TECHNICAL BULLETIN: 12-08

SUBJECT: MiniMech without Teflon Strips Approved

Teflon strips on each side of cassette bay

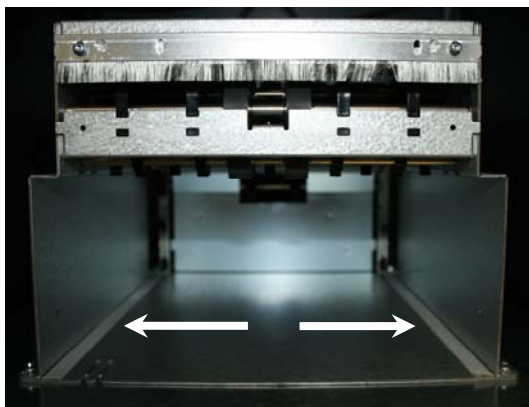
Talaris, the manufacturer of the MiniMech dispenser, has approved the use of the MiniMech (and MultiMech) without the Teflon strips found on each side of the bay where the cassette rests. Talaris will no longer produce the dispensers with these strips.

Extensive testing verified that the dispenser will operate successfully without the Teflon strips with minimal wear. This change will eliminate the issue of the Teflon strip peeling off which leaves a sticky residue. If any of these strips are found peeling, feel free to remove them and their sticky residue completely. Whenever removing one strip, always remove the other.
